FORMER CENTRAL RETAIL PARK
ROCHDALE
DESIGN & ACCESS STATEMENT
ADDENDUM

ORRD-LRW-XX-XX-PP-A-00624_P03 | JULY 2024

This Design and Access Statement Addendum has been prepared by Leach Rhodes Walker for Wilmott Dixon and Rochdale Development Agency in support of the non material amendment to the currently consented residential development in Rochdale approval reference:22/01119/FUL.

3 Bed House First Floor Plan

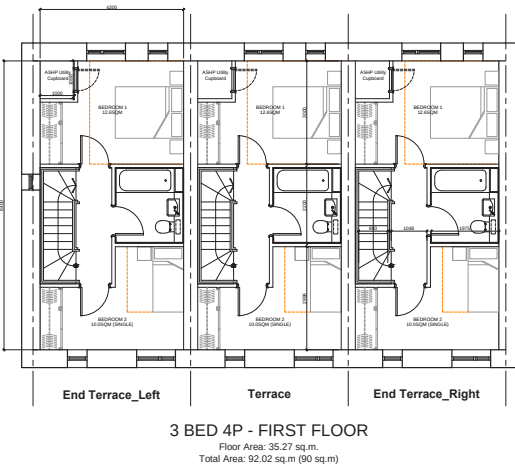
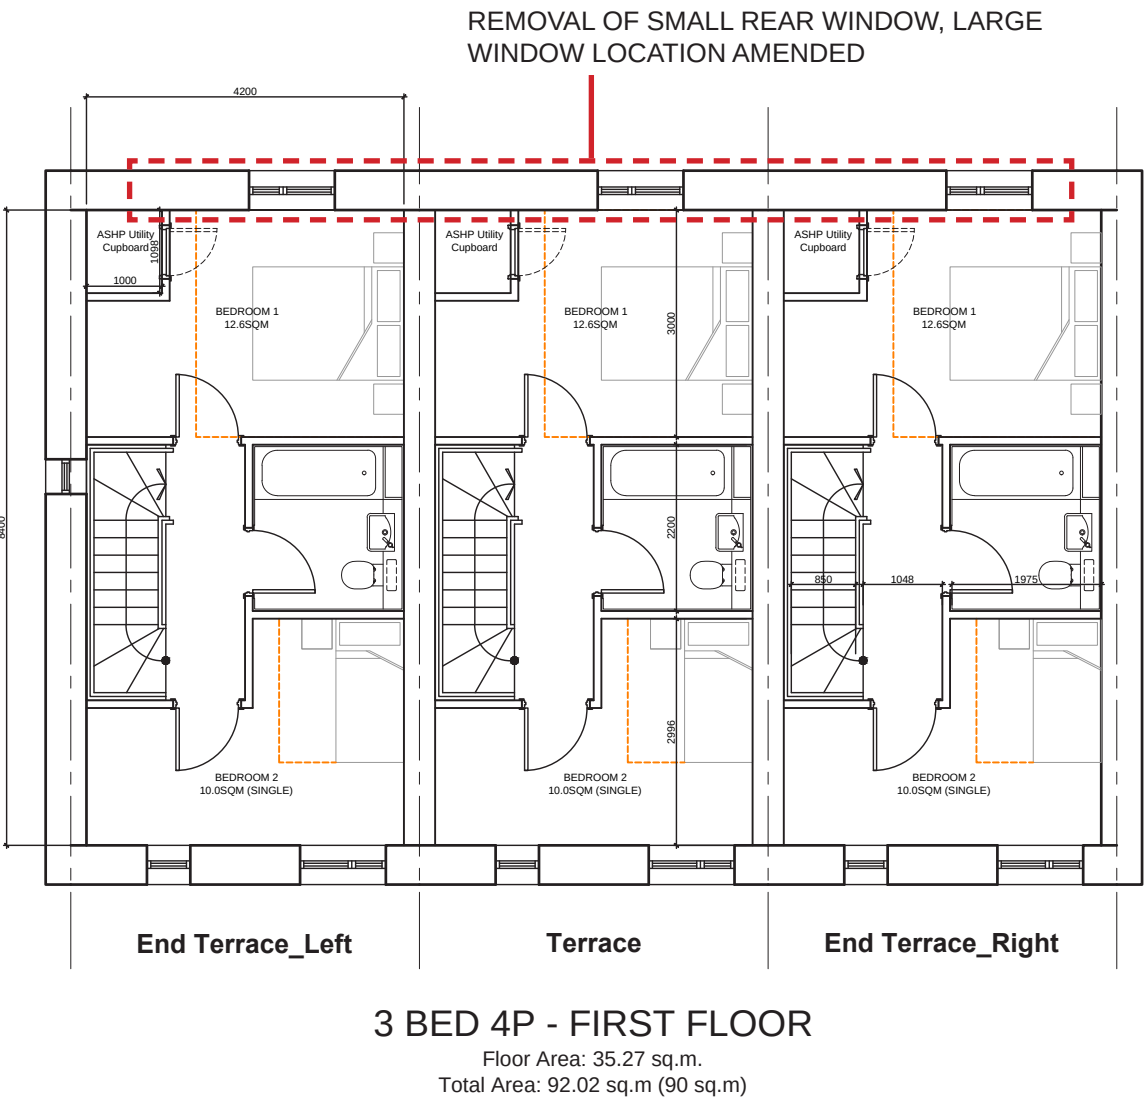
On the first floor of the 3 bed house the smaller of the two rear windows has been removed and as a result of this the larger window location has been amended to sit more centrally in the bedroom.

3 Bed House Second Floor Plan

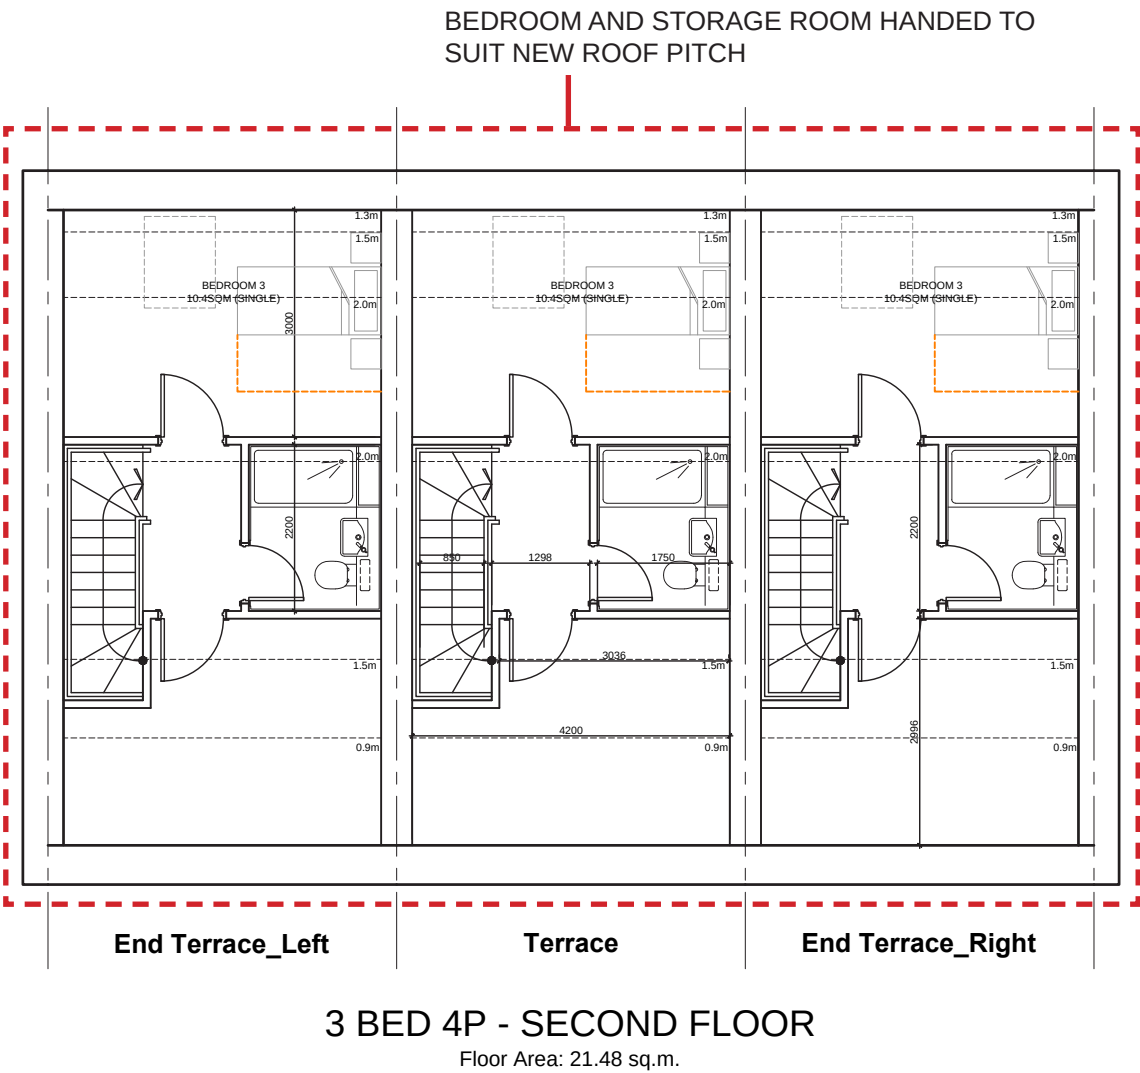
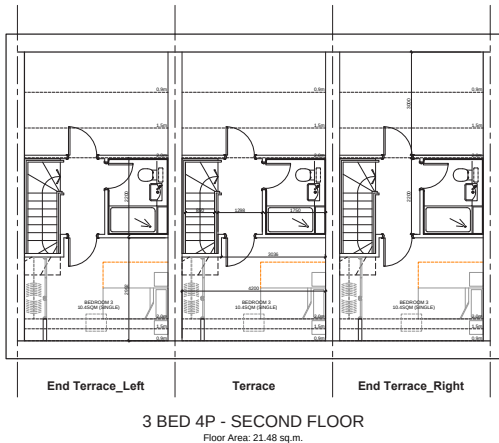
Due to a change in roof pitch for the 3 bed house type the bedroom and the storage room have been handed to suit the height of the spaces provided at second floor.

3 Bed House Roof Plan

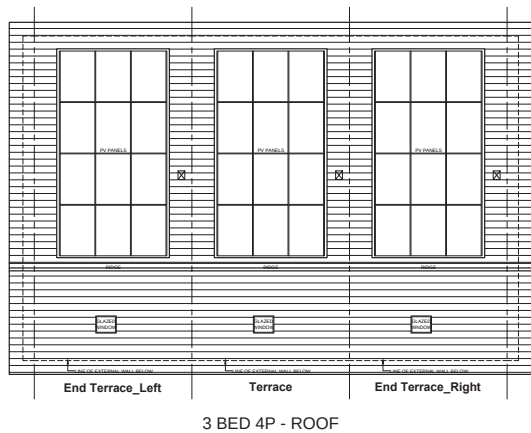
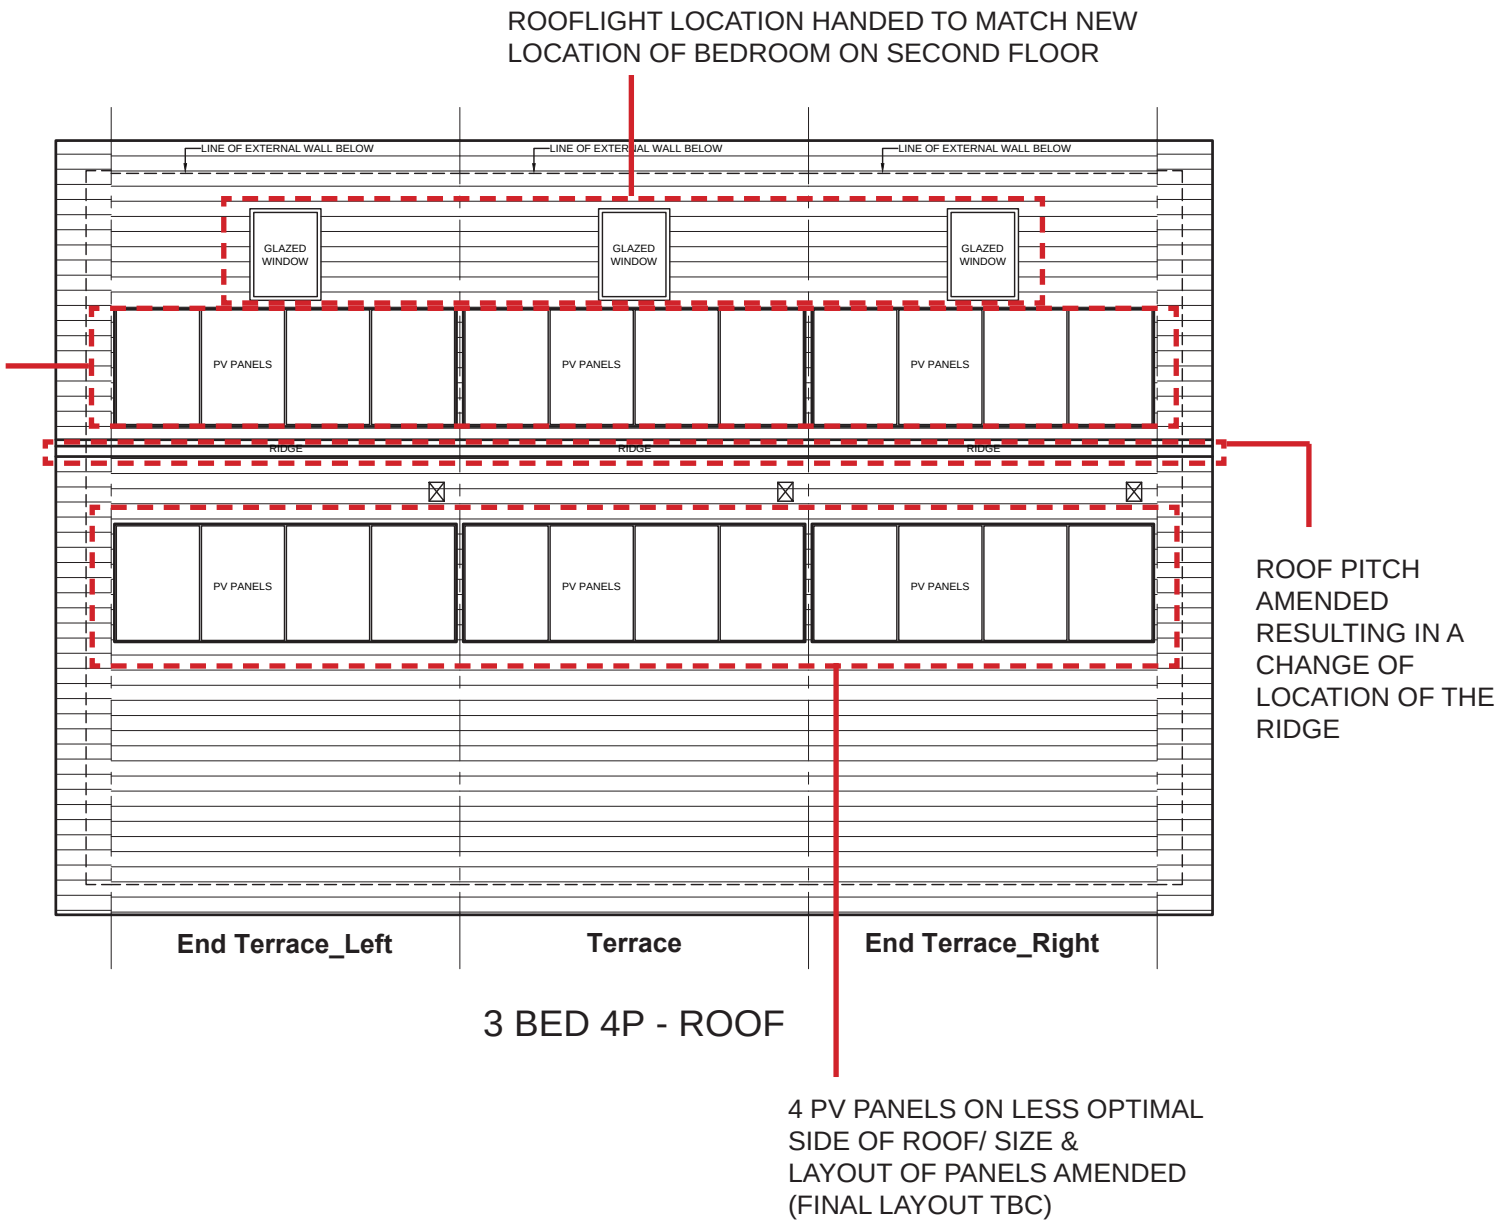
The change of roof pitch on the 3 bed impacts the location of the ridge, rooflight and PV panels. The rooflight size has increased and the location has been amended to suit the new bedroom location on the second floor. Due to this only 4 PV panels are located on the optimal side of the roof pitch. The change in roof pitch has reduced the amount of space availability, this has resulted in the lose of 4 PV panels and the relocation of 4 PV panels onto the less optimal side of the roof pitch.

3 Bed House Front and Side Elevation

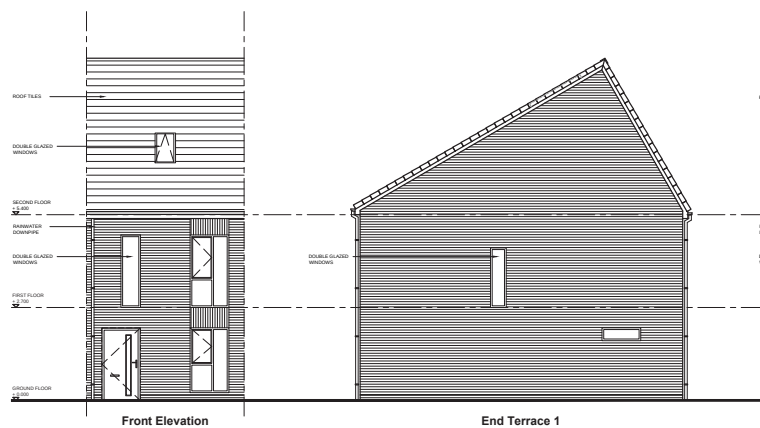
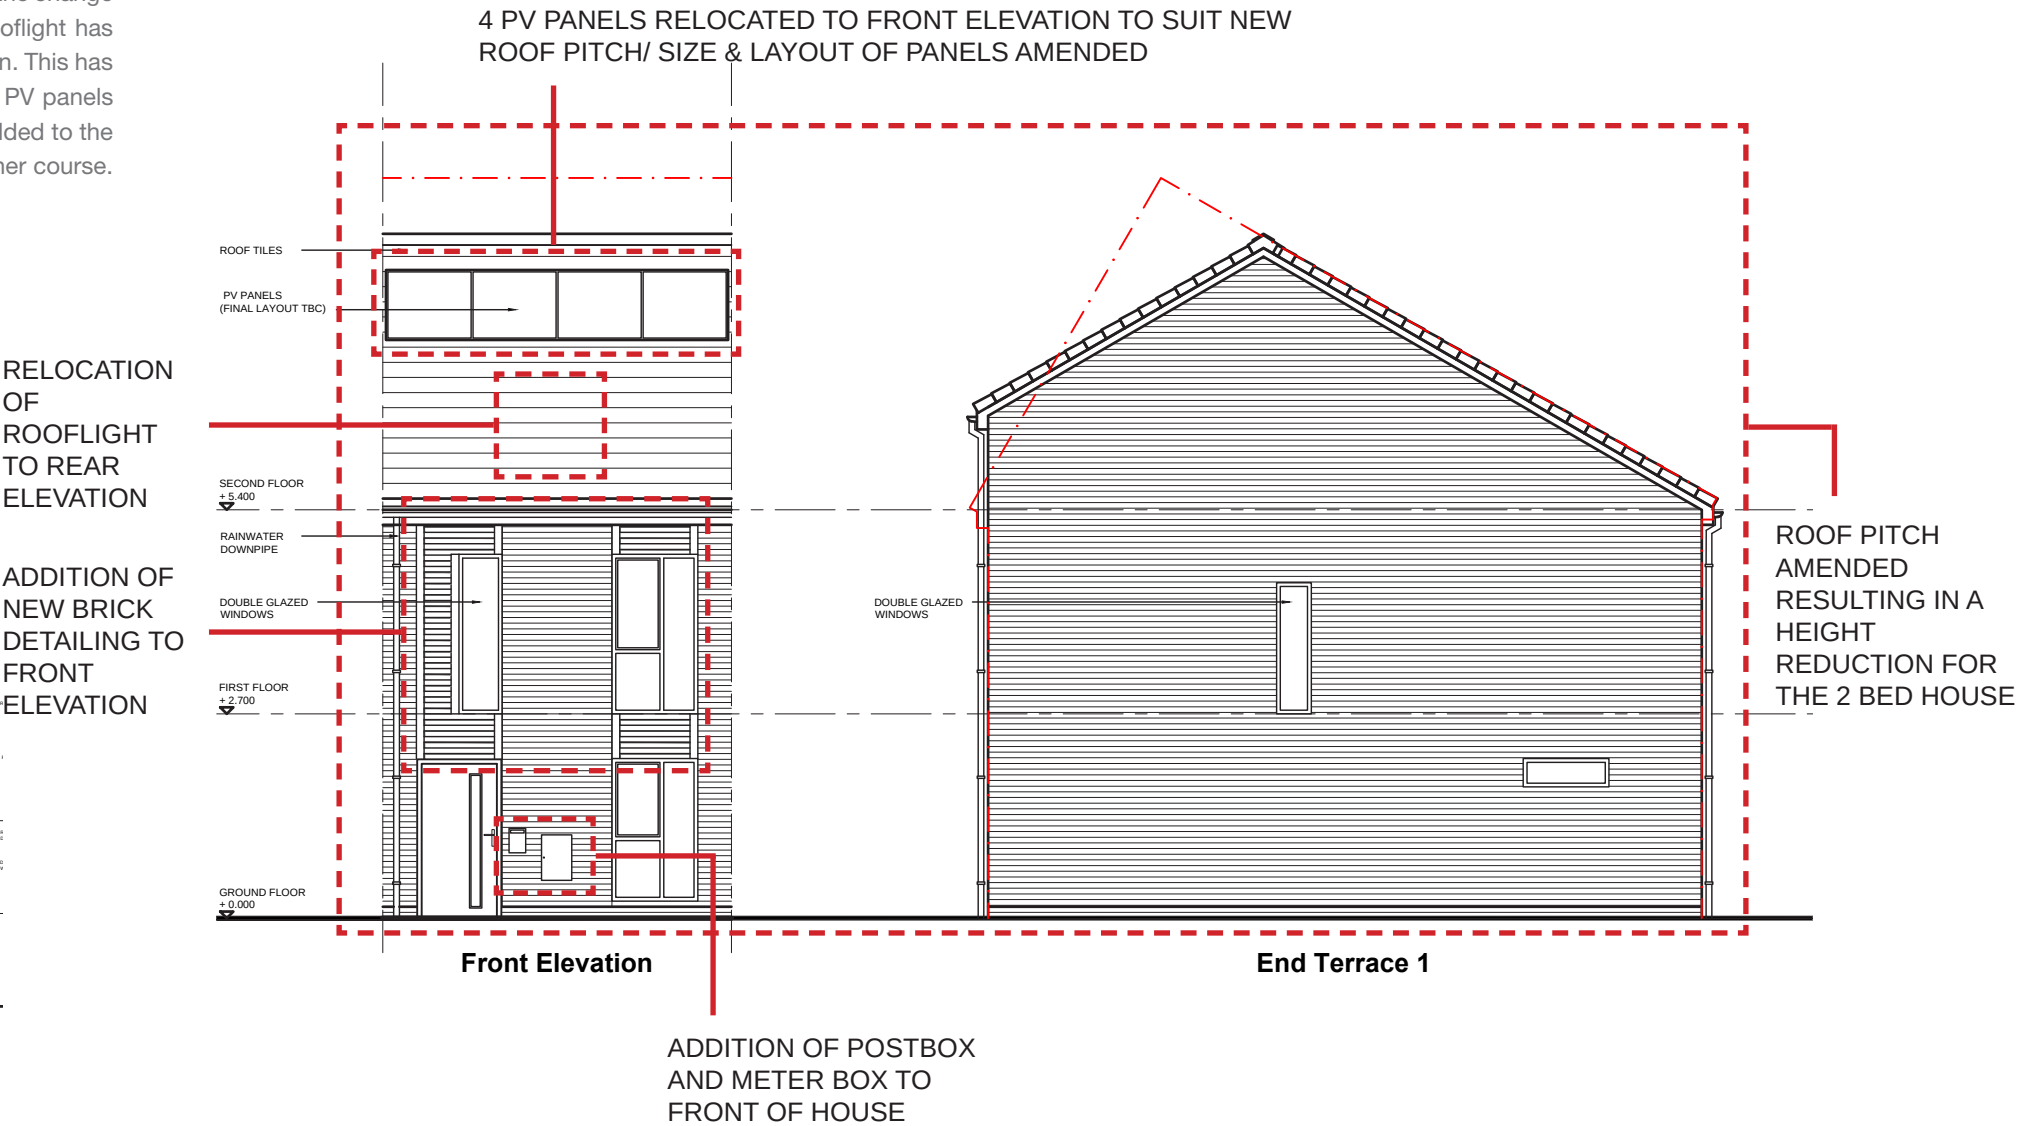
The 3 bed house front and side elevation have reduced in height due to the change in roof pitch. The number of PV panels has been reduced and the rooflight has been relocated to the rear of the house to suit the new bedroom location. This has reduced the space on the optimal side of the roof pitch resulting in 4 PV panels being relocated to the front elevation. New brick detailing has been added to the front facade including feature brickwork with a 10mm recess every other course. Also, a postbox and meter box has been added to the front elevation.

3 Bed House Rear and Side Elevation

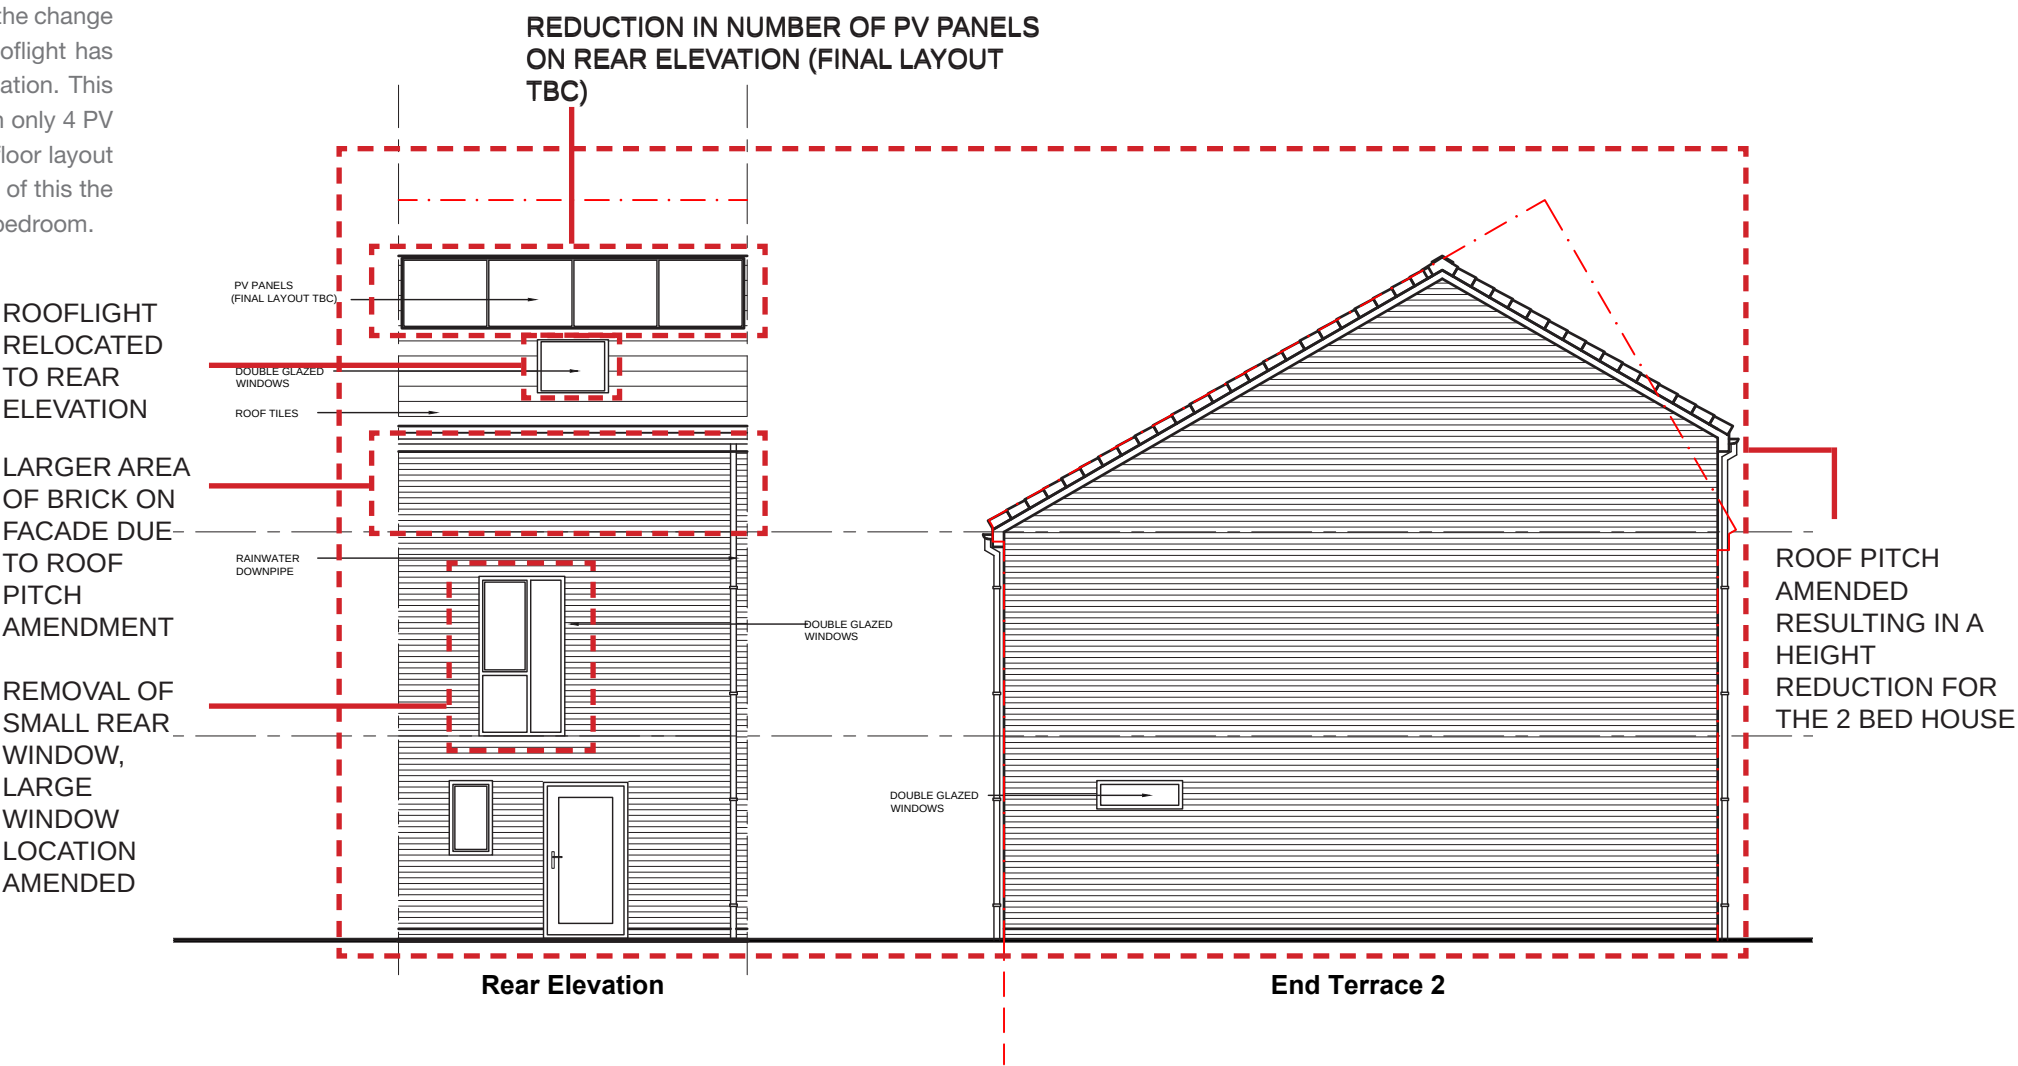
The 3 bed house rear and side elevation have reduced in height due to the change in roof pitch. The number of PV panels has been reduced and the rooflight has been relocated to the rear of the house to suit the new bedroom location. This has reduced the space on the optimal side of the roof pitch resulting in only 4 PV panels being retained on the rear elevation. As mentioned on the first floor layout the smaller of the two rear windows has been removed and as a result of this the larger window location has been amended to sit more centrally in the bedroom.
